ON-SITE SEWAGE DISPOSAL SYSTEM
HOWARD COUNTY HEALTH DEPARTMENT
BUREAU OF ENVIRONMENTAL HEALTH

ADDRESS: 14725 Roxbury Road PROPERTY OWNER: Todd & Dawn Pavuk

6 bedroom
**HOUSE LOCATION
DRAWING**
14725 ROXBURY ROAD

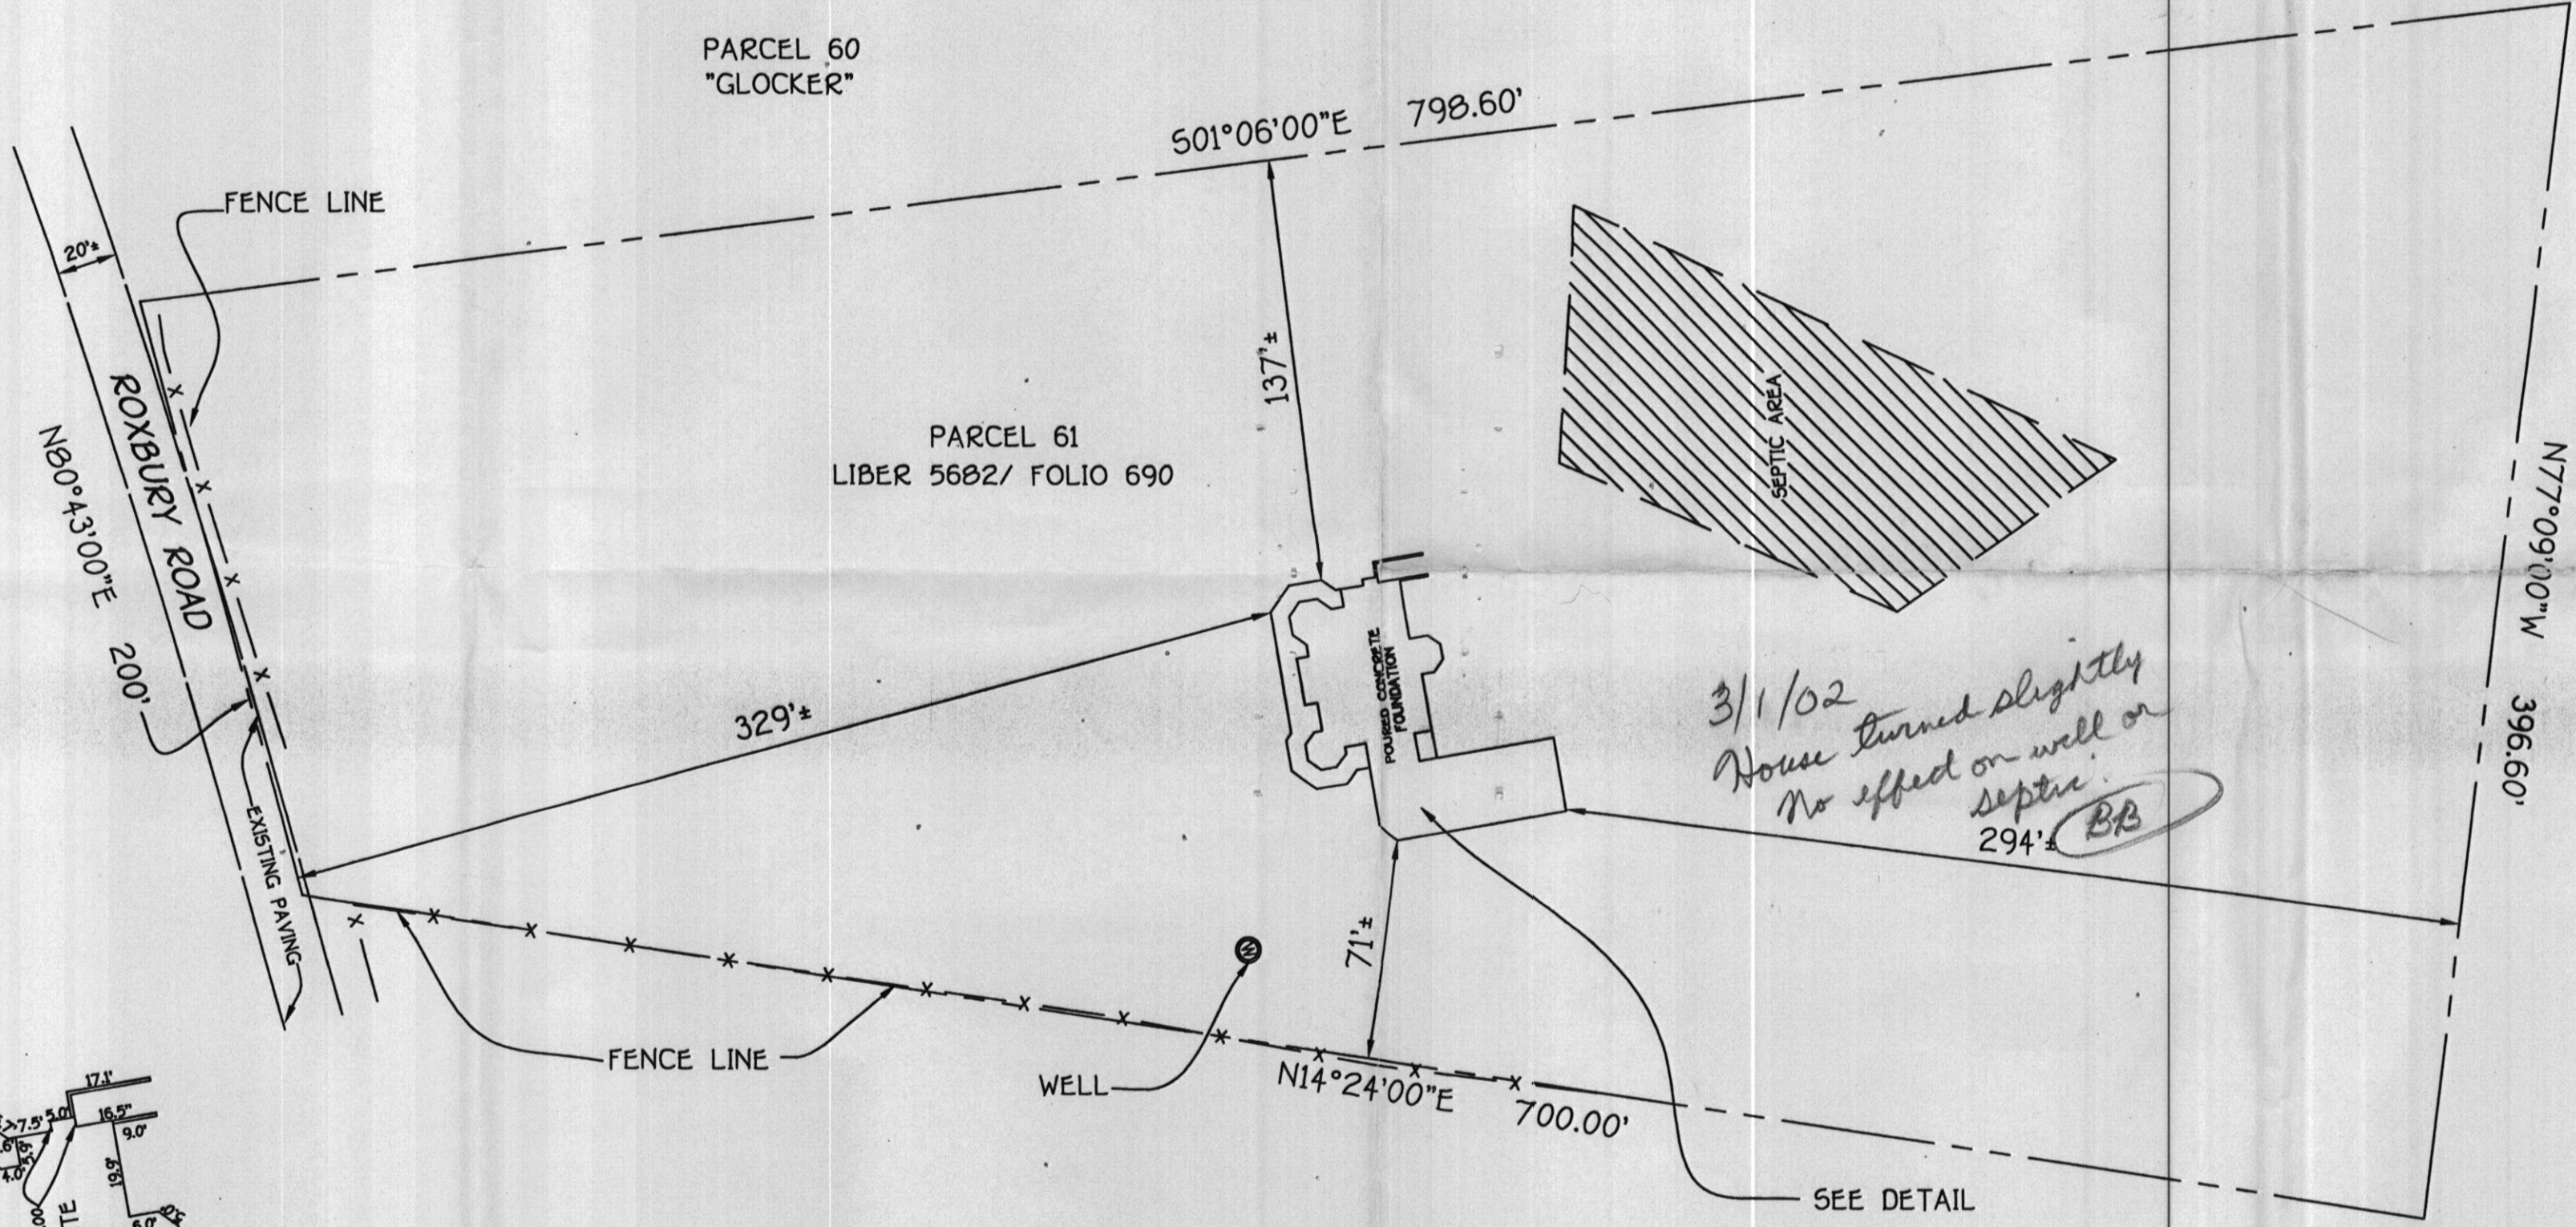
PRE-CONSTRUCTION 3/9/02 Layout per B.P. (SO) 4' inlet, 8' bottom

*3/1/02
House turned slightly
No effect on well or
septic.
294'± BB*
